## Application for Amendment

**September 2017**

<b>False Bay Coastal Study, Strand seawall and lengthening of rock revetment</b>
DEADP reference: E12/2/4/1-A3/475-2071/11

**Figure 2: Proposed conceptual seawall revetment at Bart's Corner, isometric view**

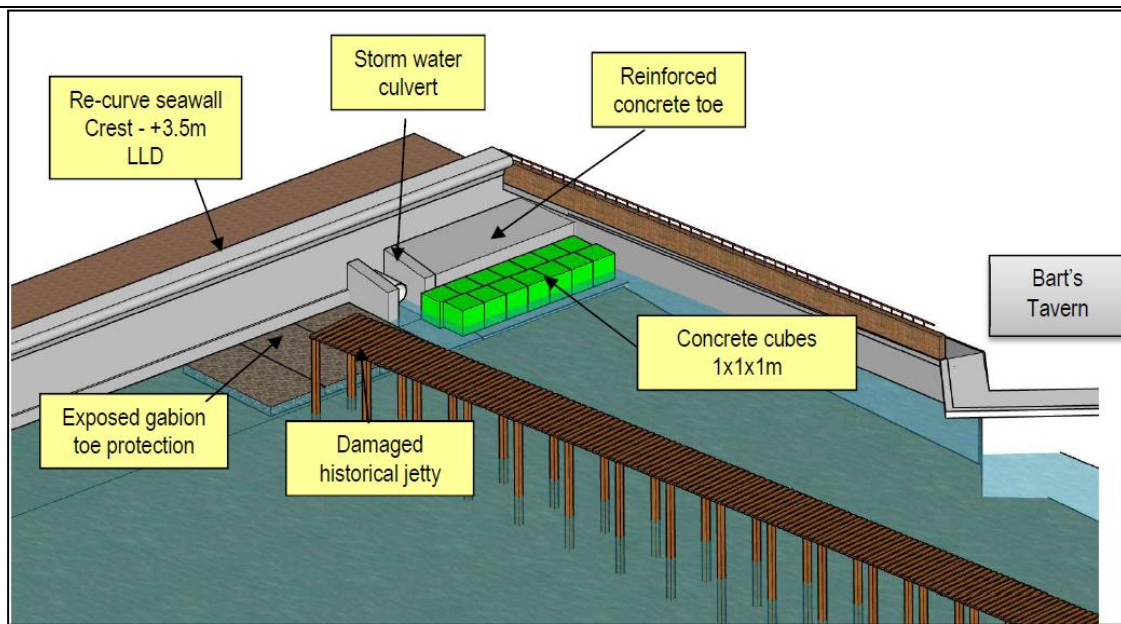
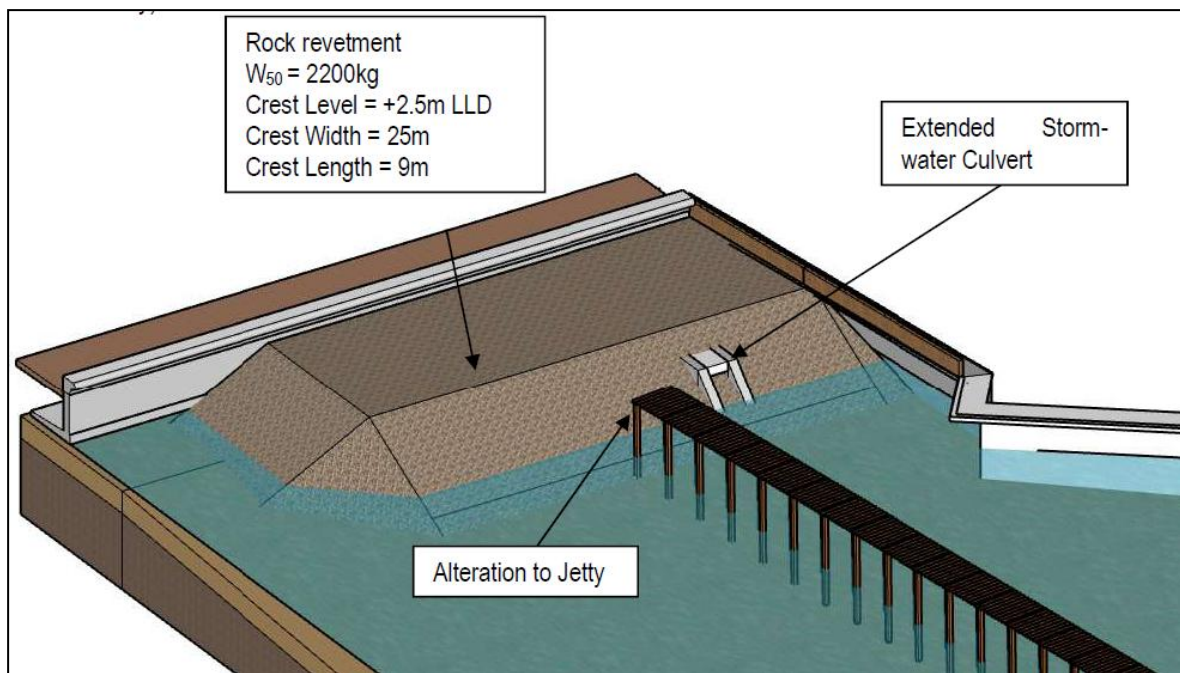
<p>4.1. Describe the amendment(s) that are being applied for:</p> <p>After the completion of the seawall (as approved by the Environmental Authorisation DEADP reference: E12/2/4/1-A3/475-2071/11) it was evident that wave overtopping and high wave heights occur at the western edge of the Strand Pavilion – Bart's Corner. The area west of the Strand Pavilion where wave overtopping and high wave energy is prevalent is referred to as "Bart's Corner". Bart's Corner is situated at coordinates 34° 7'6.98"S; 18°49'39.81"E</p> <p>Due to the foreshore channel ("Die Poort") and the geometry of the Pavilion, high wave heights occur at Bart's Corner, and subsequently; wave overtopping, seawall toe scour and wave reflection off the seawall is experienced.</p> <p>WML Coast was appointed to investigate possible remedial actions to decrease the wave overtopping and related hydraulic and morphological phenomenon at this location which is prevalent with the current installed components, as seen in Figure 1. After physical model testing and further assessment, it is proposed to amend the installation to revetment with the following parameter as seen in Figure 2:</p> <ul style="list-style-type: none"> <li>• Revetment length = 9m</li> <li>• Revetment width = 25m (refer to Figure 6)</li> <li>• Armourstone mass, M50 = 2200kg</li> <li>• Revetment crest level = 2.5m LLD (Note, the crest level will be confirmed during detail following a more detailed wave overtopping assessment.</li> <li>• Revetment slope = 1:2 (V:H)</li> <li>• Revetment toe level -1.7m LLD (0.5m trench in bedrock, excavation in bedrock required for revetment toe stability)</li> </ul>

Based on the above, the preferred option for the mitigation of the wave overtopping and scour at Bart's corner is a conventional Rock Revetment (indicated as Option 2 in Appendix 6: Design Report, page 44) in front of the new (existing) seawall.

- The construction site is easily accessible from land;
- The new (existing ) re-curve seawall will not have to be altered (for the immediate future);
- The revetment will protect the seawall from being undermined;

Figure 14: Raised seawall west of Strand Pavilion proposed conceptual configuration.

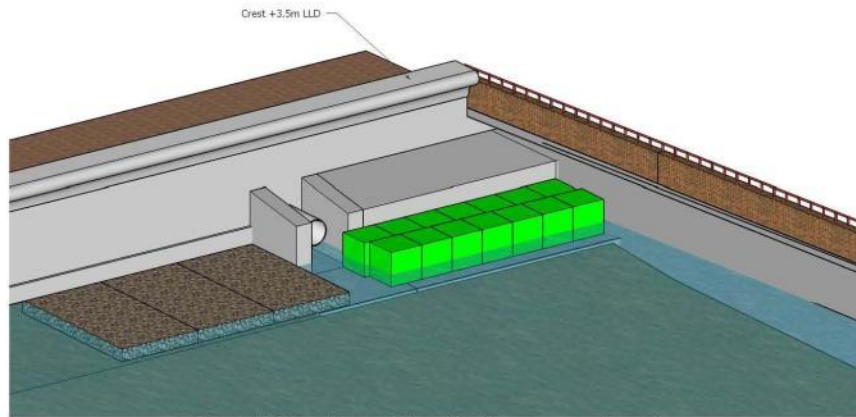
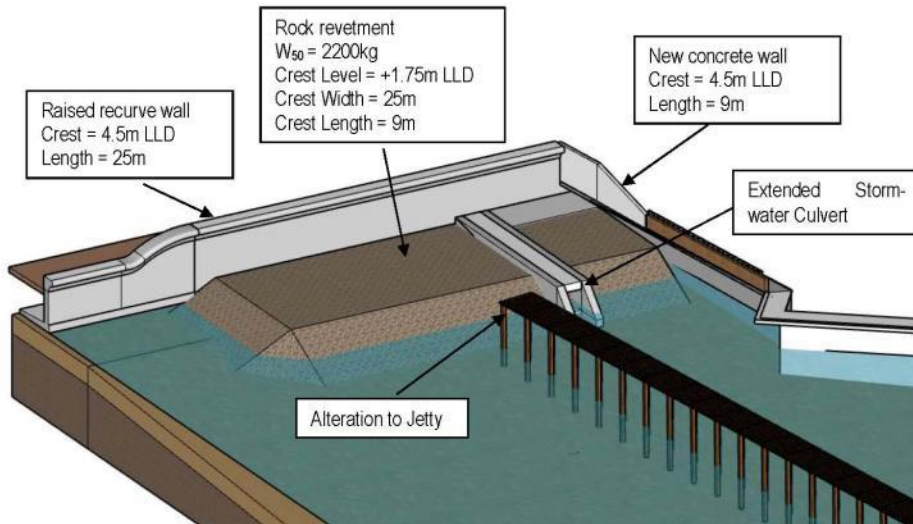
During construction of the new raised seawall the Strand Pavilion brick promenade brick wall hand railing must be demolished and replaced with a concrete (or similar) wall. Refer to Figure 14 for a conceptual sketch of the raised seawall and new concrete wall.

The new recurve seawall should span a distance of at least 25m (approximate length of eroded coastline, refer to Figure 6) from Bart's Corner. The "splash back" wall should span a length of at least 8m.

With the beach level at approximately 0m LLD the crest level of the seawall should be raised to at least 4.5m LLD (current level is +3.5m LLD). At this crest level, acceptable overtopping rates be achieved for the 1:20 year design water level for the 2011 sea-level if the effect of the revetment is ignored -note revetment is beneficial to overtopping volumes (see Table 5). The predicted overtopping volume for this seawall configuration is approximately 0.7 l/s/m. Refer to Figure 13 for a representation of the current seawall height in relation to the surrounding environment.

Figure 16: Proposed conceptual seawall revetment at Bart's Corner, isometric view.

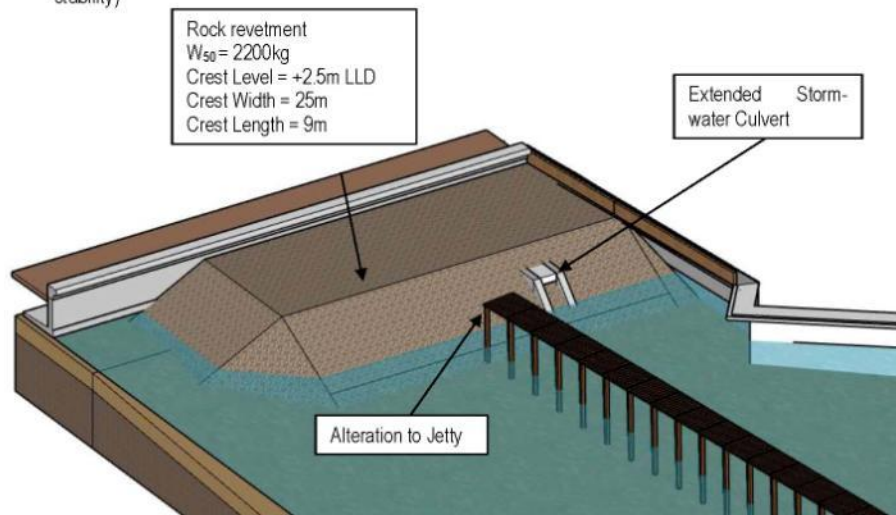
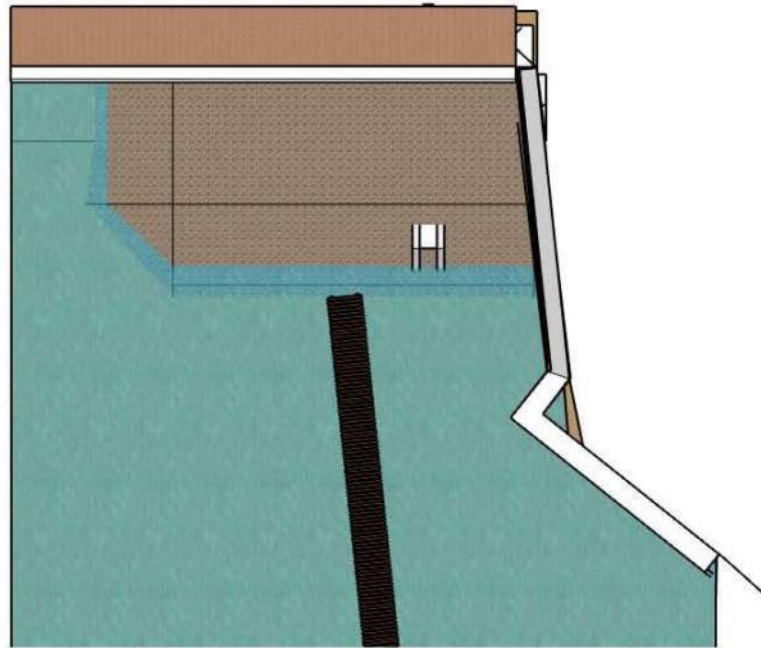
The conceptual revetment layout is illustrated in Figure 16 and Figure 17.

- Revetment length = 9m
- Revetment width = 25m (refer to Figure 6)
- Armourstone mass,  $M_{50} = 2200\text{kg}$
- Revetment crest level = 2.5m LLD (Note, the crest level will be confirmed during detail following a more detailed wave overtopping assessment)
- Revetment slope = 1:2 (V:H)
- Revetment toe level -1.7m LLD (0.5m trench in bedrock, excavation in bedrock required for revetment toe stability)
